# Access Compliance Report

## Public Rights-of-Way

### (Curb Ramps)

Intersection ID: 44001	Main Street: ELROSE_PL	Cross Street: N/A	Location: SE
ADA ID: 323A4334AA21	Ramp Type: BlendTrans1	Initial Pass/Fail: Fail	Overall Compliance: No
Codes/Mitigation Info/Possible Solution		Field Measurements/Component Compliance	
Severity Score: 12.5

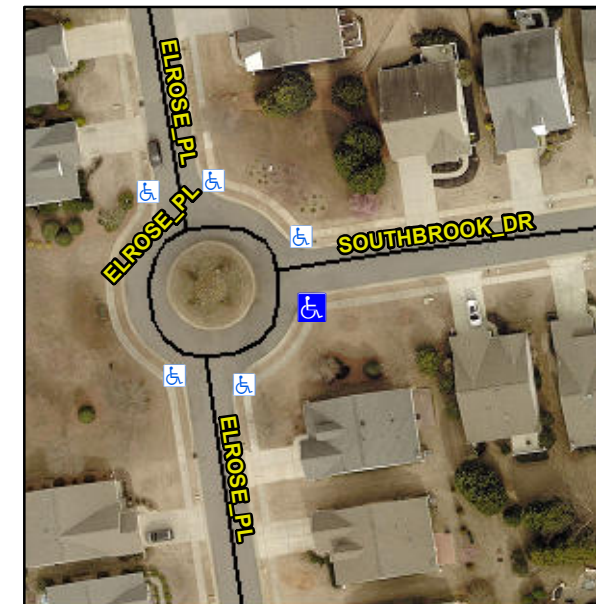
**Not Found, R304.5.3**

Compliance	Description	Data	Compliance	Description	Data
N/A	Ramp Length (in)	46.0	Yes	BlendTrans Slope (%)	4.0
Yes	Ramp Width (in)	75.0	No	BlendTrans XSlope (%)	6.3
N/A	Flare Type LT	N/A	N/A	Flare Type RT	N/A
N/A	Flare Slope LT (%)	N/A	N/A	Flare Slope RT (%)	N/A
N/A	Flare Traversable LT?	N/A	N/A	Flare Traversable RT?	N/A
N/A	Landing Length (in)	N/A	N/A	DWS Provided?	N/A
N/A	Landing Width (in)	N/A	N/A	DWS Contrast?	N/A
N/A	Landing Slope (%)	N/A	N/A	DWS Length (in)	N/A
N/A	Landing X Slope (%)	N/A	N/A	DWS Full Width?	N/A
N/A	Landing Curb? (Y/N)	N/A	N/A	DWS Offset (in)	N/A
N/A	Shared Landing?	N/A			
N/A	Gutter Ponding?	N/A	N/A	Gutter Slope (%)	N/A
N/A	Gutter Lip Ht (in)	N/A	N/A	Gutter X Slope (%)	N/A
N/A	Painted X Walk1?	No	N/A	Painted X Walk2?	N/A
	X Walk 1 Direction	To N		X Walk 2 Direction	N/A
	X Walk 1 Width (in)	N/A		X Walk 2 Width (in)	N/A
	X Walk 1 Slope (%)	2.1		X Walk 2 Slope (%)	N/A
	X Walk 1 X Slope (%)	6.8		X Walk 2 X Slope (%)	N/A

N/A	Ramp inside XWalk1?	N/A	N/A	Ramp inside XWalk2?	N/A
	Road Slope (%)	6.8		Clear Space?	N/A
	Road X Slope (%)	2.1	N/A	Clear Space to XWalk (in)	N/A
N/A	Any Obstructions?	N/A	N/A	Storm Grate/Utility Hazard?	N/A
	Obstruction Type			Storm Grate/Utility Type	
		N/A			N/A
			Yes	Surface Condition? (G/P)	Good
			No	Curb Slope (%)	26.6

**Remove & Replace Curb Ramp With Two New Directional Ramps or Equivalent.**
